UNITED STATES PATENT AND TRADEMARK OFFICE

10/798,109

Office Action Summary	Application No. 10/798,109	Applicant(s) MEYER, HERMANN	
	Examiner BRANON C. PAINTER	Art Unit 3633

DETAILED ACTION

Reproduced from U.S. Patent No. 4,692,051

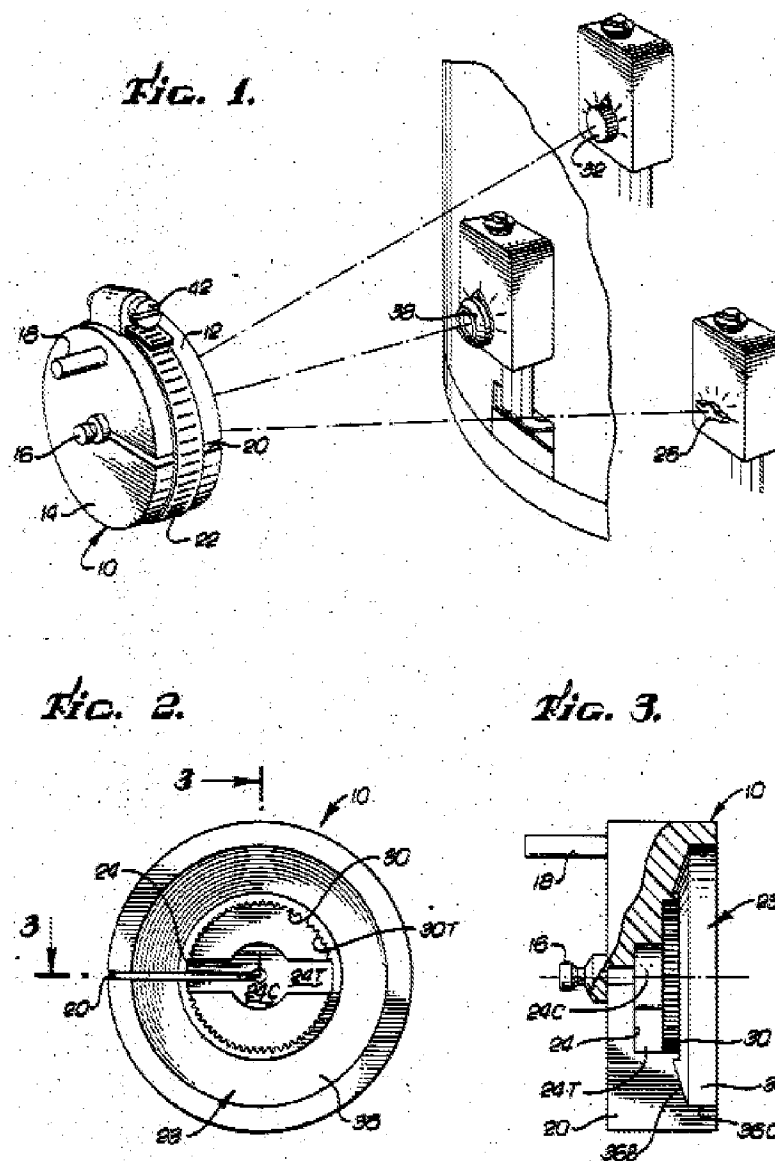
An arrangement comprising a tubular element ("knob" 32, Fig. 1) connectable to a body extending into the tubular element (a shaft inherently must extend from the box to the knobs in Fig. 1, as the device is analog, not digital), and a tension ring ("cylindrical body" 12, Fig. 1) adapted to embrace, by an inner surface ("inner portion" 23, Fig. 2), an outer wall at an end of the tubular element, the tension ring adapted to extend axially along the tubular element and adapted to apply a clamp force to the tubular element (via "clamp" 22, Fig. 1) so that the tubular element acts via an inner wall of the tubular element on the body extending into the tubular element to clamp the tubular element on the body; wherein the tension ring includes a first axial section (from "outer portion" 14 through "serrated ring" 30, Fig. 1,3) and a second axial section ("frosto-conical portion" 36B, Fig. 3) contiguous in axial direction to the first axial section and is adapted to rest by only the first axial partial section of the inner surface ("serrated ring" 30, Fig. 2) against the outer wall of the tubular element ("knob" 32, Fig. 1) and is adapted to exert a clamp action on the

outer wall of the tubular element; wherein at the end, a wall of the tubular element on which the tension ring is to be positioned includes a smaller thickness than a contiguous axial region of the tubular element (The base of "knob" 32 includes an arrow that points to the temperature demarcations. At that base point the arrow and knob are thicker than the knob is at the outer facing end, Fig. 1); wherein the first axial section is configured to face an end face of the end of the tubular element.

10. Regarding claim 4, Stansbury, Jr. et al. discloses a second axial section that does not rest against the tubular element (“frosto-conical portion” 36B, Fig. 3).

11. Regarding claim 5, Stansbury, Jr. et al. discloses a second axial section that is axially thicker than the first axial section (Fig. 3).
12. Regarding claims 6 and 7, Stansbury, Jr. et al. discloses a second axial section farther from the center axis than the first axial section (second axial section “frosto-conical portion” 36B, Fig. 3) with a cut-out in the second axial section (“frosto-conical portion” 36B, Fig. 3).

13. Regarding claim 16, Stansbury, Jr. et al. discloses a tension ring with a plurality of clamp points along the inner circumference of the ring to rest against the tubular element (“serrated ring” 30, Fig. 2).

14. Regarding claim 17, Stansbury, Jr. et al. discloses an inner surface with three clamp points (“serrated ring” 30, Fig. 2).
15. Regarding claim 18, Stansbury, Jr. et al. discloses a tension ring with integrally molded protrusions (“serrated ring” 30, Fig. 2). The examiner notes that claim 18 is considered to be a product-by-process claim due to the phrase “molded.” The patentability of the product does not depend on its method of production. Determination of patentability is based on the product itself. See MPEP 2113. If the product in the product-by-process claim is the same as or obvious from a

16. Regarding claim 19, Stansbury, Jr. et al. discloses equidistant clamp points on the tension ring (“serrated ring” 30, Fig. 2).
17. Regarding claim 20, Stansbury, Jr. et al. discloses a weak point between each two adjacent clamp points (valleys in “serration ring” 30, Fig. 2).
18. Regarding claim 26, Stansbury, Jr. et al. discloses a weak spot adapted to act as a joint (valleys in “serration ring” 30, Fig. 2).
19. Regarding claim 27, Stansbury, Jr. et al. discloses an adapter having all of the applicant’s claimed structure as discussed with regard to claim 1.
20. Claims 1, 3, and 22-23 are rejected under 35 U.S.C. 102(b) as being anticipated by Stansbury, Jr. et al. (U.S. Patent No. 4,692,051).
21. Regarding claim 1, Stansbury, Jr. et al. discloses an adapter having all of the applicant’s claimed structure, including:

An arrangement comprising a tubular element (“cylindrical body” 12, Fig. 1) connectable to a body extending into the tubular element (“knob” 32, Fig. 1), and a tension ring (“clamp” 22, Fig. 1) adapted to embrace, by an inner surface (“inner portion” 23, Fig. 2), an outer wall at an end of the tubular element, the tension ring adapted to extend axially along the tubular element and adapted to apply a clamp force to the tubular element so that the tubular element acts via an inner wall of the tubular element on the body extending into the tubular element to clamp the tubular

element on the body; wherein the tension ring includes a first axial section and a second axial section contiguous in axial direction to the first axial section and is adapted to rest by only the first axial partial section of the inner surface ("clamp" 22 is capable of resting with only a partial section in contact with "cylindrical body" 12, Fig. 1) against the outer wall of the tubular element ("cylindrical body" 12, Fig. 1) and is adapted to exert a clamp action on the outer wall of the tubular element; wherein at the end, a wall of the tubular element on which the tension ring is to be positioned includes a smaller thickness than a contiguous axial region of the tubular element (the thickness at "body" 12 is greater than the thickness at "pivot point" 16, Fig. 1); wherein the first axial section is configured to face an end face of the end of the tubular element.

22. Regarding claim 3, Stansbury, Jr. et al. discloses a body including a cylindrical element ("knob" 32, Fig. 1).
23. Regarding claim 22, Stansbury, Jr. et al. discloses a tubular element with a hollow shaft ("cylindrical body" 12 acts as shaft with hollow portion "hollow cylinder" 24C, Fig. 2).
24. Regarding claim 23, Stansbury, Jr. et al. discloses a body including a drive shaft ("knob" 32 acts as a drive shaft as it transmits mechanical power when rotated, Fig. 2).
25. Claims 1, 12, 14-15, and 24-25 are rejected under 35 U.S.C. 102(b) as being anticipated by Stansbury, Jr. et al. (U.S. Patent No. 4,692,051).

26. Regarding claim 1, Stansbury, Jr. et al. discloses an adapter having all of the applicant's claimed structure as set forth above, with the exceptions that the following are represented by different parts: tubular element ("knob" 38, Fig. 1) and first axial region ("frosto-conical portion" 36B, Fig. 2). The examiner notes that, as with "knob" 32, "knob" 36 includes an arrow indicator at the base that is thicker in diameter than the knob body, as well as the fact that the body of "knob" 36 tapers as it approaches its outermost end, meeting the added limitations of claim 1.

27. Regarding claim 4, Stansbury, Jr. et al. discloses Stansbury, Jr. et al. discloses a second axial section ("cylindrical portion" 36C, Fig. 2).
28. Regarding claim 12, Stansbury, Jr. et al. discloses a projection on the end face of the unattached end of the tubular element (raised projecting portion on outer face of "knob" 38, Fig. 1).

29. Regarding claim 14, Stansbury, Jr. et al. discloses a shoulder transitioning between the unattached end to the contiguous axial region (beveled region between raised projecting portion and base portion of "knob" 38, Fig. 1).

30. Regarding claim 15, Stansbury, Jr. et al. discloses a tension ring positionable in an axial position directly next to the shoulder ("cylindrical body" 12, Fig. 1).

31. Regarding claim 24, Stansbury, Jr. et al. discloses an outwardly protruding projection arranged as a circumferential flange (raised projecting portion on outer face of "knob" 38, Fig. 1).

32. Regarding claim 25, Stansbury, Jr. et al. discloses a tension ring restable against the shoulder ("cylindrical body" 12, Fig. 1).

35. Applicant's arguments filed 12/20/07 have been fully considered but they are not persuasive.
36. Applicant argues that "there is no indication whatsoever by Stansbury that cylinder 12...is adapted to apply a clamp force to the knob 32 so that the knob 32 acts via an inner wall of the knob 32 on a body extending into the knob 32 to clamp the knob 32." However, as discussed in the rejection above, Stansbury does disclose these elements. Stansbury teaches an analog system for adjusting temperature. The examiner notes again that because the system is analog, it must include a series of parts that are physically connected to one another. As with any other analog temperature control, a shaft is inherently present and extending into the body of "knob" 32/38, since the system would be inoperable without said shaft. Physically rotating "body" 12 causes the temperature to increase or decrease. A slip-free connection between "body" 12 (applicant's tension ring) and "knob" 32/38 (applicant's tubular element) is achieved by tightening "tension ring clamp" 22,

which causes "body" 12 to apply a clamp force to "knob" 32/38. This clamp force, in turn, causes "knob" 32/38 to act via an inner wall to clamp onto the shaft (applicant's body) extending into "knob" 32/38, allowing the rotation of "body" 12 to cause the slip-free rotation of both "knob" 32/38 and the shaft.
